**Re: MM Docket No. 99-325**

**EX PARTE COMMENTS**

I, Alan W. Jurison am personally filing these *ex parte* comments and analysis in response to the *ex parte* filing of National Public Radio (“NPR”) on November 6, 2009 of an *ex parte* meeting that was held on November 5, 2009 related to the NPR Labs Advanced IBOC Coverage and Compatibility Study (“NPR Labs Study”). In addition, I have comments related to the joint letter filed by NPR and iBiquity Digital Corporation (“iBiquity”) on November 5, 2009 (“Joint Agreement”).

Figure 21 - Differences between car and room listening at 35dBS

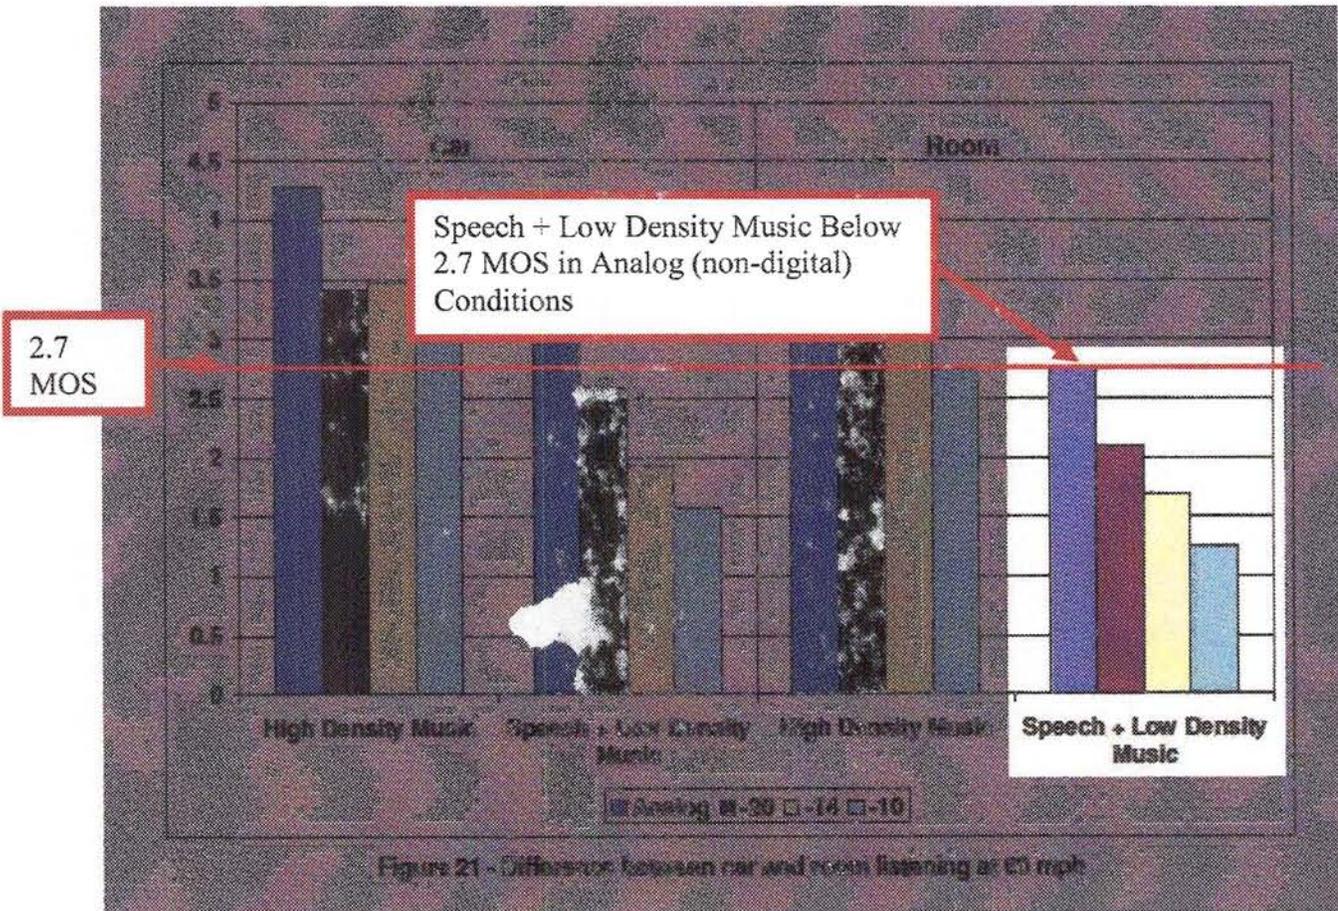
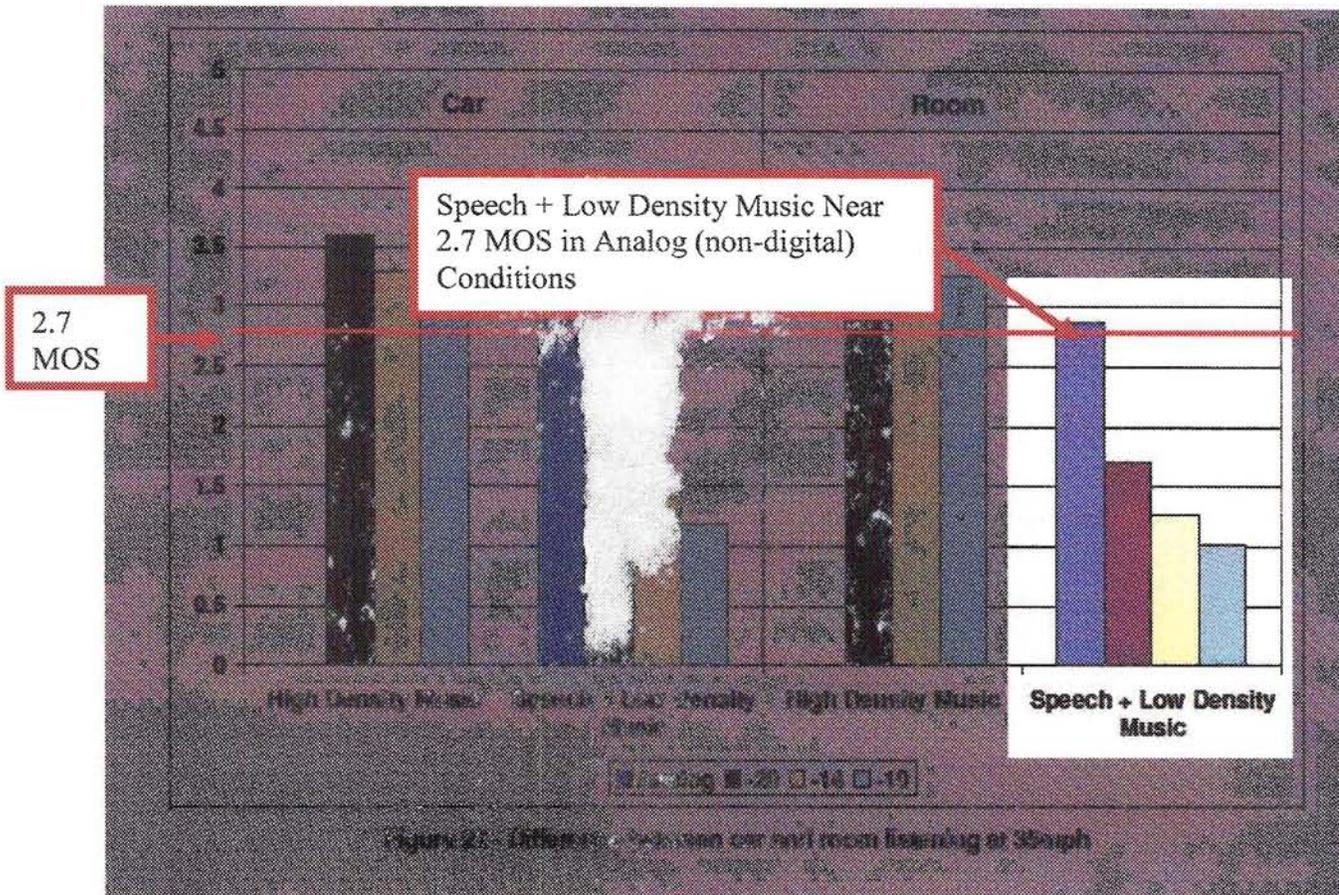
Section 4.4.1 of the NPR Labs Study, Figures 21 and 22 shows in-room samples using Speech and Low Density Music. The analog, -20dBc, -14dBc, and -10dBc all fall near or below a 2.7 MOS. Using their methodology, analog-to-analog interference is objectionable and would cause the listener to tune out. However, the NPR tests were conducted at the point where the analog-to-analog interference was within FCC limits. NPR Labs makes no reference to this. If a 2.7 MOS is the true point where listeners tune away, then NPR Labs has significant explaining to do. NPR Labs Study shows in Figures 21 and 22 that the existing analog-to-analog system (no digital carriers) causes objectionable interference and in these situations people wouldn't be listening. Clearly, that is not the case, but NPR Labs uses the 2.7 MOS criteria in their analysis.

It is also important to note that Figures 21 and 22 are the last you'll ever see the analog-to-analog MOS plotted in the report. This should raise a red flag, because NPR Labs isn't showing us the full picture. Why is the analog component not shown in figures 23 and 24? Given the trend of how the analog performs in Figures 21 and 22, it is likely that the analog system (i.e. no digital carriers) would also perform poorly and be unacceptable on the MOS scale in the Speech + Low Density Music tests. If that's the case, there is an issue with either the specific receiver they used or their overall methodology.

Given the above, NPR Labs should have immediately followed up with testing additional receivers before drawing conclusions from just one receiver. If additional receivers showed similar results, then the 2.7 MOS criteria NPR selected is inaccurate. Perhaps the testing of additional receivers would show the Kenwood KTC-HR100's mono/stereo blending circuit causes listeners to tune out while other, more widely deployed OEM receivers do not. Given the results that NPR Labs has shown, in the current analog domain, with no digital carriers at all, that the desired signal is already being tuned out – and if that's the case, then we're creating a protection methodology that has a higher standard than our current level of analog-to-analog broadcasts, for which NPR has not provided any justification.

Figure 24 - Speech and Low Density Music at -20, -14 and -10 dBc

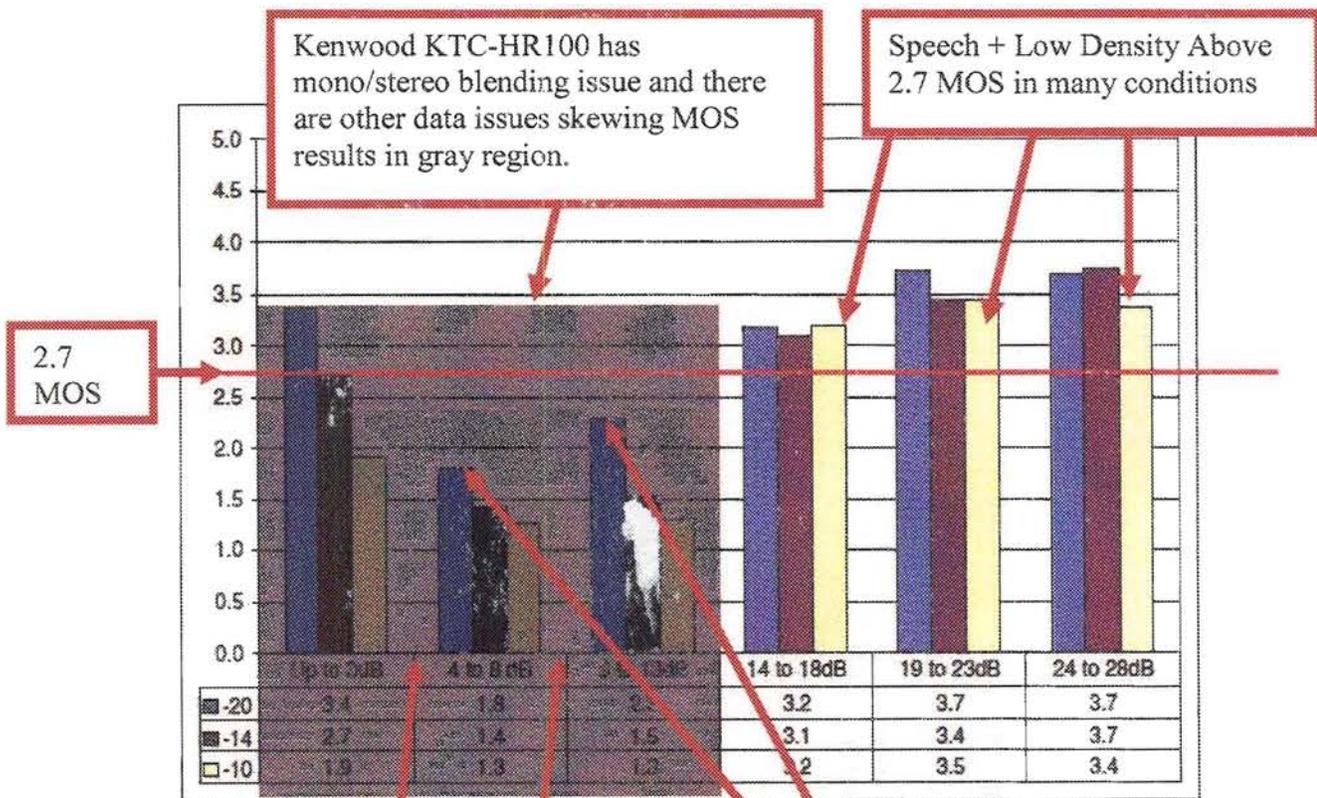
Figure 24 of the NPR Labs report shows that there is objectionable interference received in the 4 to 13dB region. However, according to their own figure, even today's digital operations of -20dBc fall below a 2.7 MOS. NPR makes no mention of this. If you are to believe the NPR report, existing IBOC operations at -20dBc already are "detrimental" because they produce scores below a 2.7 MOS, thus showing no basis for a power increase at all. Why would NPR support a power increase above -20dBc based on this data?

**Analog-Analog Components Not Shown.** Trend of data here and data from Figures 21 and 22 would suggest Analog-Analog would be impaired and fall below 2.7 MOS.

**-20dBc Unacceptable In These Tests.** If you believe the data in Figure 24, -20dBc operation also falls below a 2.7 MOS and is allegedly already "detrimental" and causing interference.

Figure 24 - Speech and Low Density Music at -20, -14 and -10 dBc

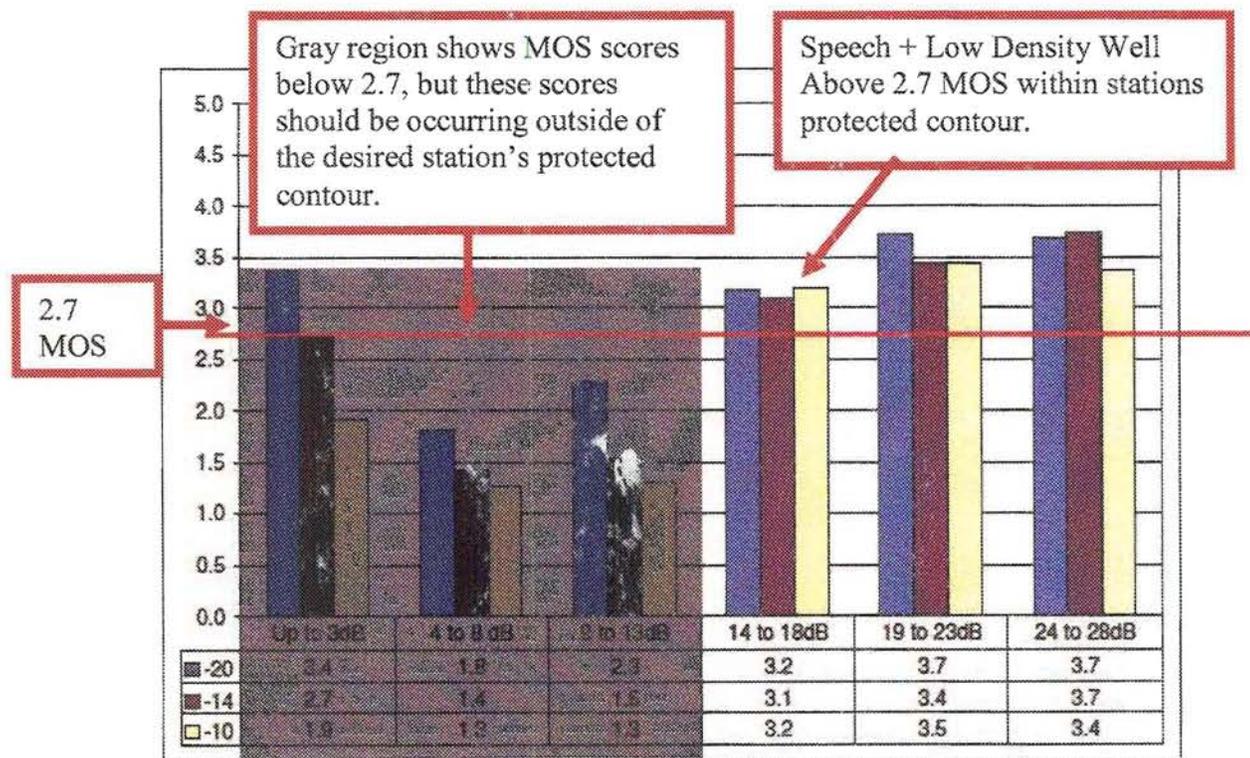
When adjusting for the correction factors as listed on Page 30 of their report, NPR states that there is a 8dB correction factor which needs to be applied to the measured data to correspond with the FCC(50,50) and FCC(50,10) standards for predicting interference. When doing so, the measured results would fall into the 14 to 18dB region of Figure 24. Accordingly, when applying the correction factor NPR shows on Page 30, anything below the “14 to 18dB” range would actually be located beyond the desired station’s protected service contour under normal conditions.

NPR’s own data shows that digital operations at -20dBc, -14dBc, and -10dBc actually do not cause MOS scores below 2.7 in the protected contour under normal conditions, meaning objectionable interference does not exist within the protected contour, even on Speech and Low Density Music tests under normal conditions.

While many stations enjoy coverage beyond their protected service contour, the Commission does not protect stations or listening beyond the protected service contour. NPR is providing data and creating an interference standard that protects stations beyond their protected contour, which should not be permitted because it is counter to all Commission policies as it relates to the FM band.

**Top:** Figure 39 from *Appendix C* of NPR's Report: WRNI, Zoomed in to Areas of Poor D/U  
**Bottom:** Zoomed in Longley-Rice study showing WRNI's poor signal strength in these areas. Full Longley Rice study map available in Exhibit B.

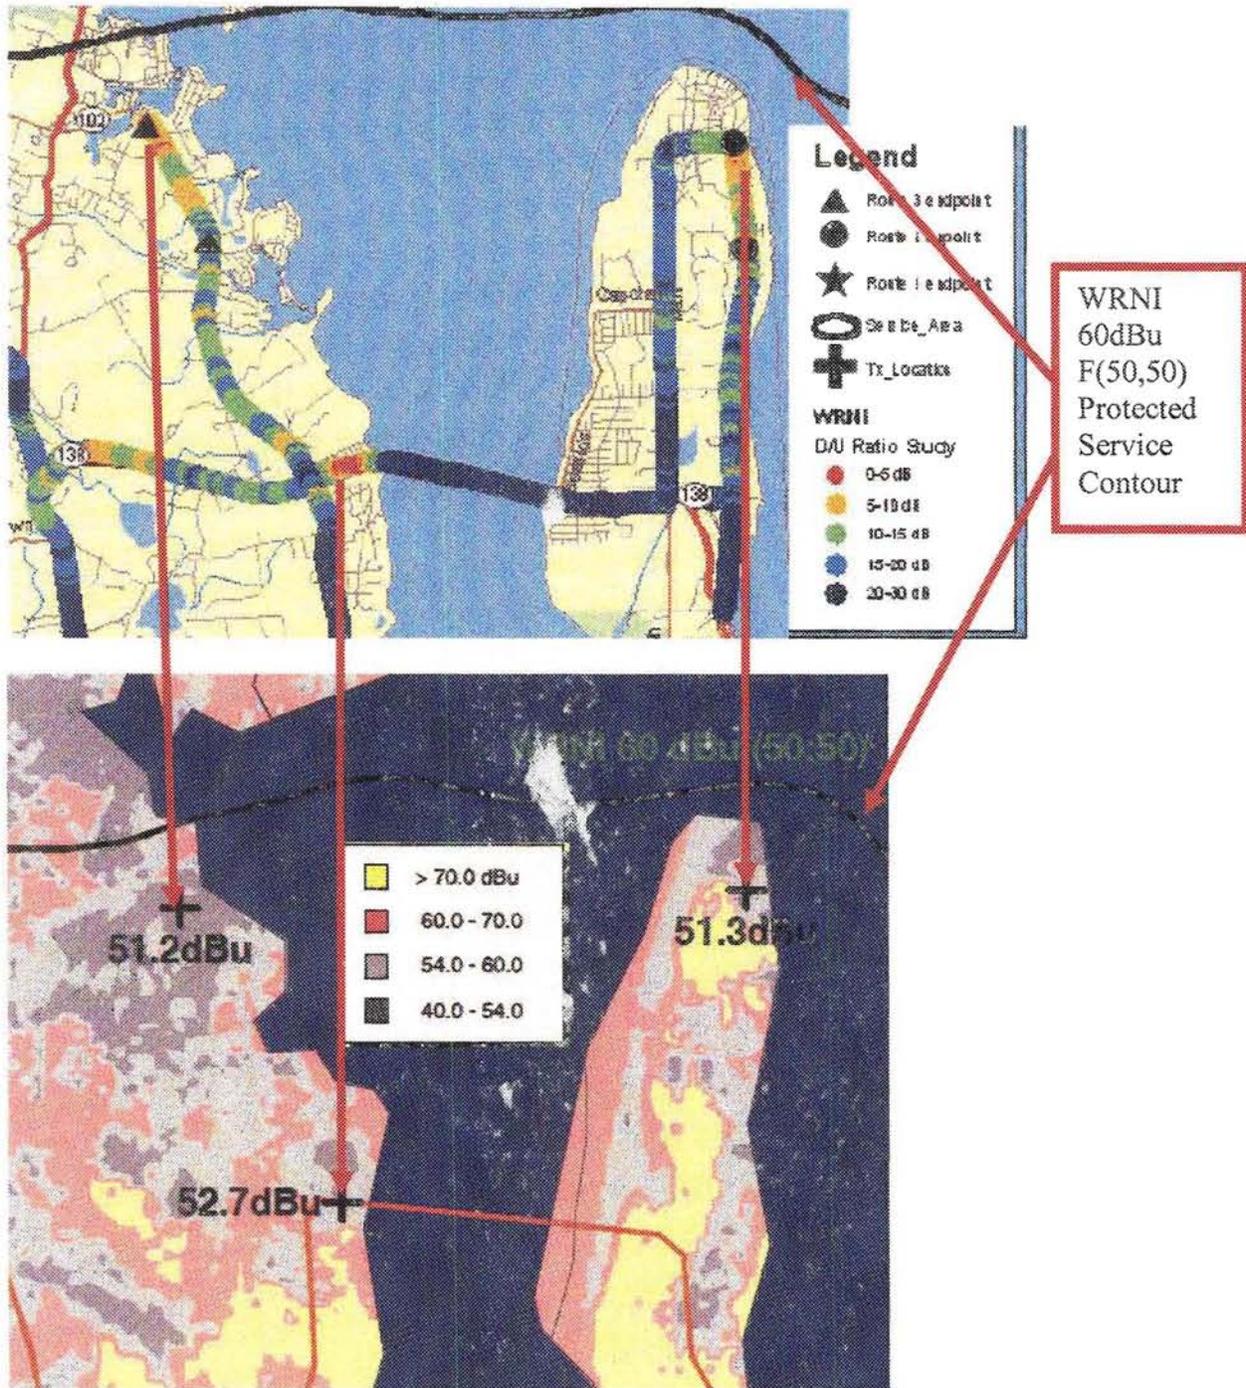
The analog data, which has been omitted from Figure 24 is very important. Looking at NPR's map of WRNI(FM) Rhode Island in *Appendix C*, Figure 39, you can see that there are D/U ratios inside of WRNI's protected 60dBu service contour which are below the 14-18dBu D/U ratio. Even when considering the correction factor, there are many sections where there are 0-5dB D/U (denoted with red dots) and 5-10dB D/U (denoted with yellow dots). If we're in the station's protected contour, WRNI should always be at least 6dB (14dB after correction) higher than the undesired station. How can this be? It's because WRNI has a very distant, weak, and obstructed signal in these locations.

While the FCC 60dBu F(50,50) goes well beyond these areas of unacceptable D/U ratios, a Longley-Rice propagation model shows very low predicted signal in these exact same regions. Unfortunately, NPR did not provide a log of Field Strength data (measured in dBu) along the same test route for this station. If they did provide this data, you will likely find values being recorded well below 60dBu.

On the next page, you will see a Longley-Rice plot of WRNI compared to the D/U map data that NPR has provided in *Appendix C* of their report. You'll note three major regions where the D/U ratios become unacceptable. On the Longley-Rice plot, these regions are shaded in various forms of gray, showing received signal strengths of 40-54dBu in the general area that the D/U ratio data which NPR collected. While NPR has not provided exact location coordinates, I've outlined three points on the map proximate to the NPR route showing a predicted signal strength between 51-53dBu.

I have had a lot of experience "traveling signals" and comparing them to both FCC and Longley-Rice prediction models. Anyone listening to WRNI in these locations, in an analog-to-analog situation, listening to speech and light music programming, would hear significant signal impairments, and likely score it with an MOS of below 2.7. Why did NPR not collect and/or provide the analog-to-analog MOS scoring data in this situation? This is very concerning because, if the analog reception without any digital carriers is unacceptable, then these points should not have been considered in their analysis. With the analog signal impaired to the point where a listener would tune away, digital operation are not going to be any better. NPR continues to hold digital interference to a higher standard than analog.

Note: Within WRNI's protected service contour, due to terrain and other propagation issues, WRNI's analog signal is poor in this area and digital data points should be dropped.

Figures 43 (left) and 44 (right) from Appendix D of NPR's Report, of KBPN, Zoomed in to Areas of Poor D/U (left), but also poor received signal strength (right).

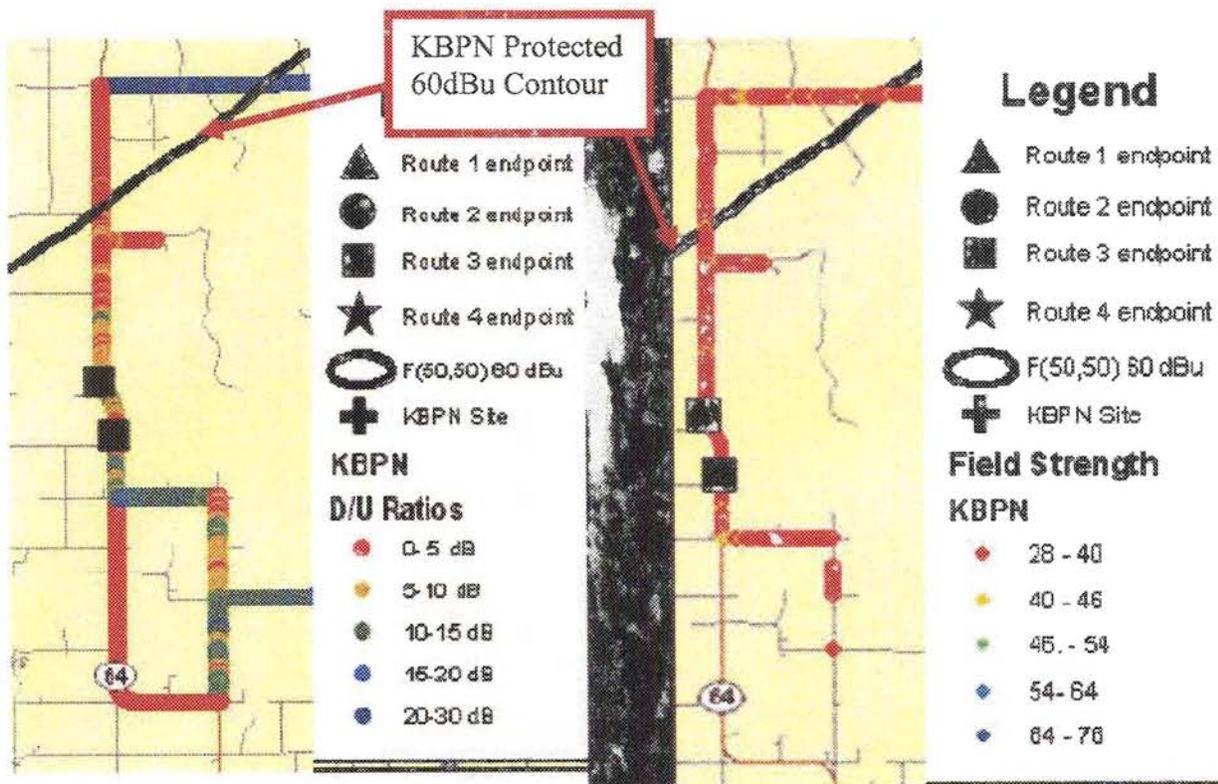
Let's look at another example from NPR's report. Appendix D, Figure 43, shows D/U ratios data as collected on KBPN. On the next page, Figure 44 is a list of Signal Strength collected on KBPN at the same data points (You'll note, there is actually a lot of data on Route 64 missing from Figure 44).

In the case of the KBPN results, although many of the measurements are being taken within its protected 60dBu contour, you'll notice in Figure 43 D/U ratios of between 0-5dB and 5-10dB. This would normally be cause of concern. But, looking to Figure 44, and you'll see that the received signal of KBPN in many of these same locations was between 28-40dBu. If NPR would have presented the analog-to-analog MOS data in this situation, you would likely find it below a 2.7 MOS, especially in speech and low-density music situations.

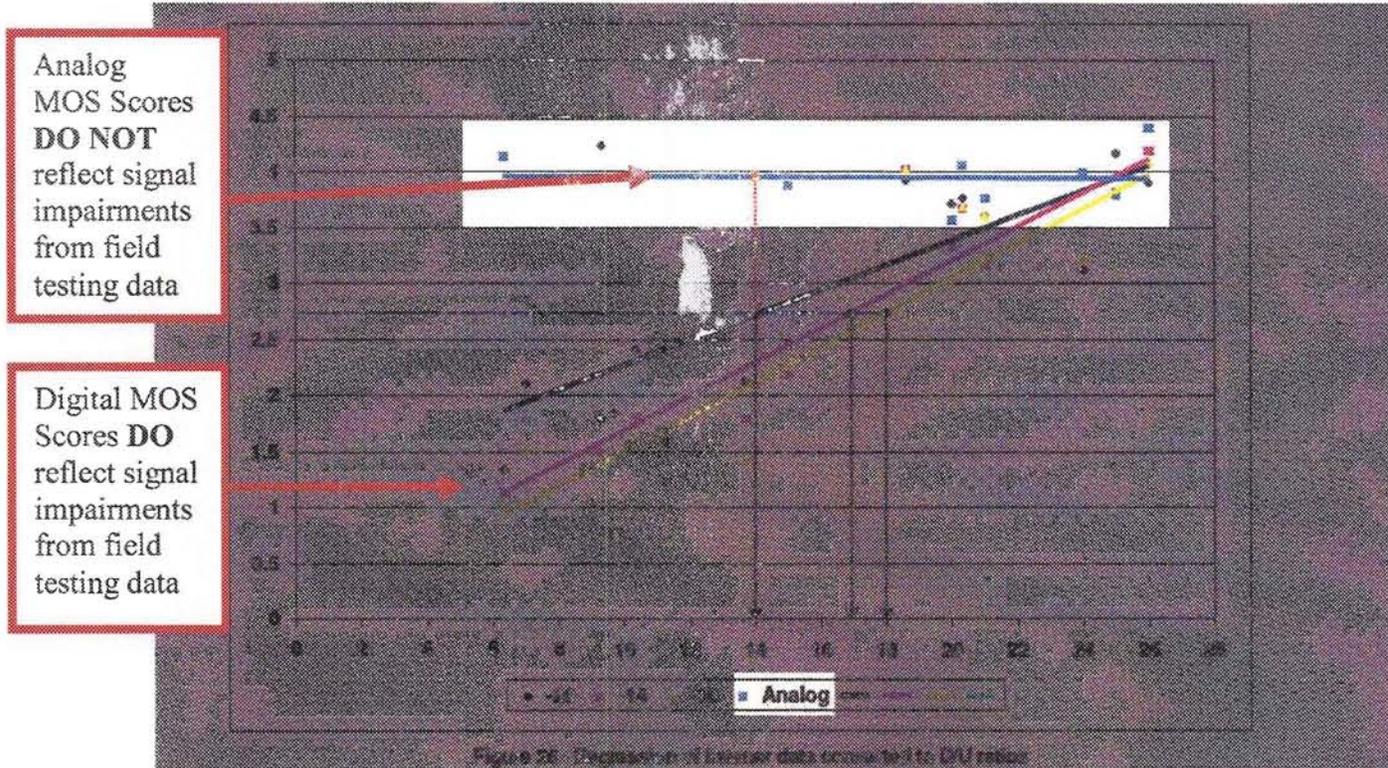
The problem is, what I have shown is one section of the KBPN data and one section of WRNI data. There are several more areas on these stations that I have not outlined graphically which exhibit the same problem. When you look at the other test stations in Appendix E and F, KLDN and KBWA, they too have the same issue. Many data points that have bad D/U ratios have received signal strengths in the 32-45dBu range for KLDN and 33-44dBu range for KBWA. These received signals are simply unusable, unacceptable, and should be discarded.
